Access Compliance Report

Public Rights-of-Way

(Pedestrian Signals)

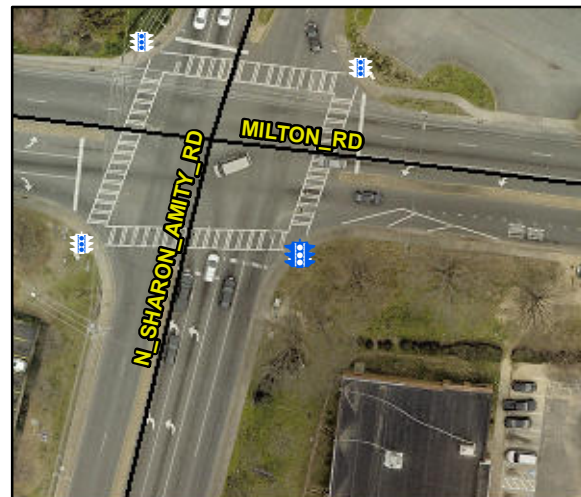
Surveyor Notes: TEXT HT 5/16

PROW/ADA: R410.6, TMUTCD 4e.08, R404.2, R406.2, R209.1, MUTCD 4e.10

Possible Solutions: Replace Signal Push Button With APS Button on New Post. Remove & Replace Sign.
